## PUBLIC UTILITIES COMMISSION

**Subject:** Salt Creek Substation—Review of Minor Project Refinement Request #8

Subject: Additional Temporary Work Spaces and Landscape Area Modification of Plant Palette (MPR Request #8)

**ATTACHMENT 1 – Salt Creek Eastern Restoration:  
Irrigation in Non-Impacted Areas**

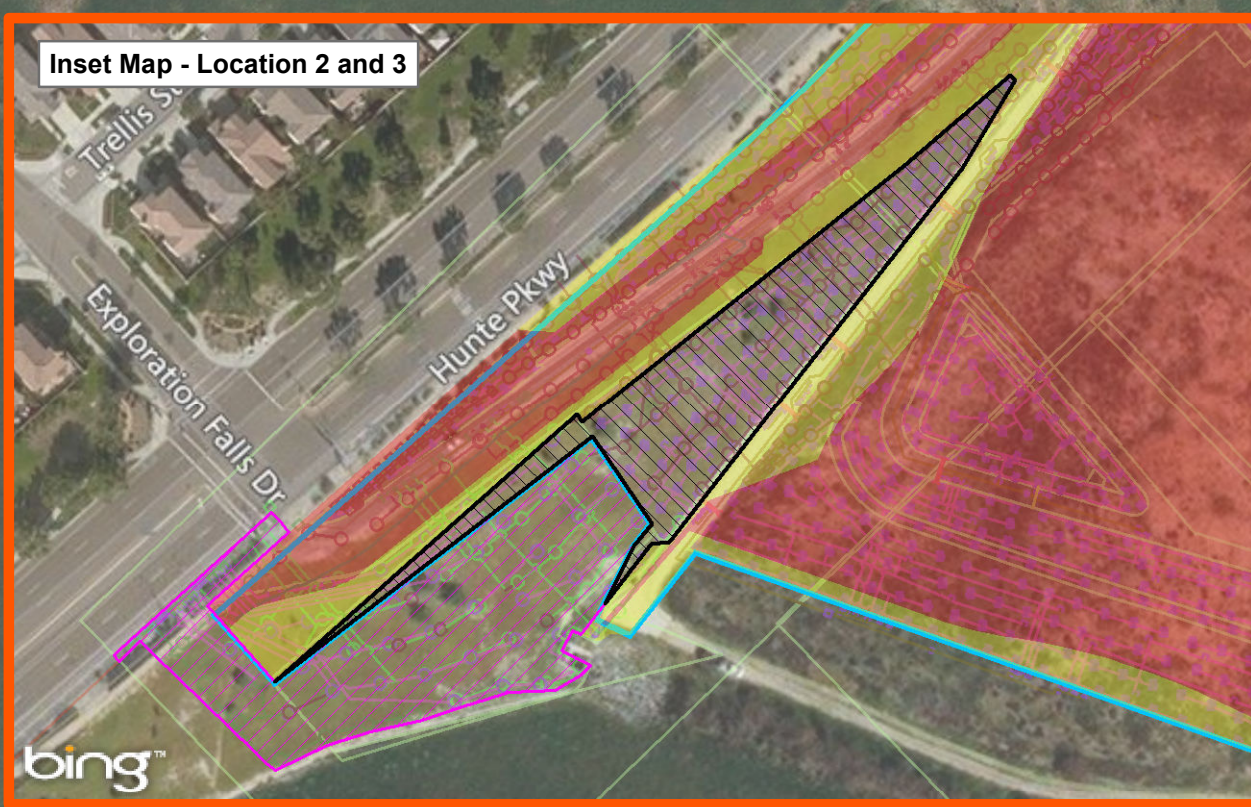
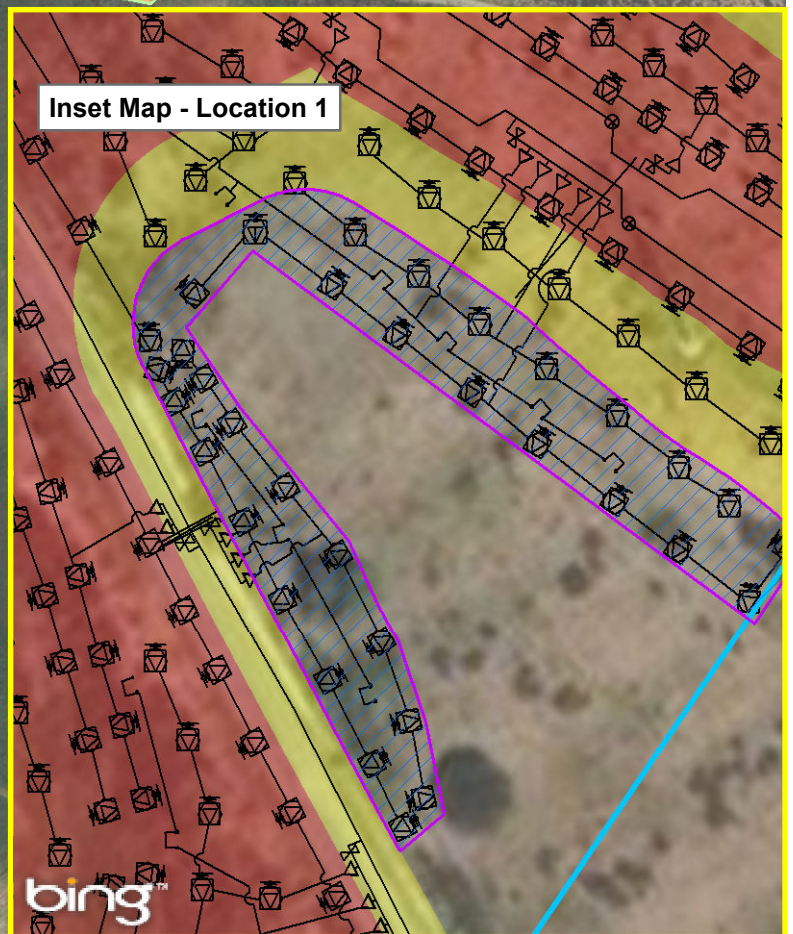
2. Temporary Extra Work Space, Location 1: During a field review of the eastern area, it was noted that the Landscape Plan includes irrigation that encroaches into approximately 0.18 acres of vegetation outside of the previously approved temporary impacts limits, as shown in Attachment 1, Location 1. The encroachment occurs in an area of non-native grassland that does not contain sensitive plant species. As required by Applicant Proposed Measure (APM) Bio-4, this temporary disturbance area will receive irrigation and revegetation as documented in

the Landscape Plan. Due to the fact that the Landscape Plan is final and approved, and irrigation design relies on this configuration, SDG&E is requesting this MPR #8 include the 0.18 acre area. Per the requirements of APM Bio-2, SDG&E would address the 0.18 acre in the Natural Community Conservation Plan post-construction report, and would restore the area per the Landscape Plan (and this MPR request).

3. Temporary Extra Work Space, Location 2: During the field review, it was noted that the irrigation plans approved by the City of Chula Vista include improvements along the ice plant embankment, outside of the approved temporary work areas. This area includes approximately 1.68 acre of landscape/ornamental and developed area. Work activities in this location would include replacement and reconnection of irrigation lines. Ice plant on the slopes would remain during construction, and once irrigated, is expected to fully recover without additional planting. However, if ice plant does not recover, planting would occur consistent with Landscape Plan requirements for the adjacent disturbed ice plant slopes.

MPR #8 would not result in a new impact or increase the severity of a previously analyzed impact; therefore, no supplemental or subsequent CEQA review is required to address MPR #8. The actions proposed in MPR #8 are consistent with the CPUC approved FEIR. MPR #8 is approved consistent with the conditions included in the MMCRP for the project.
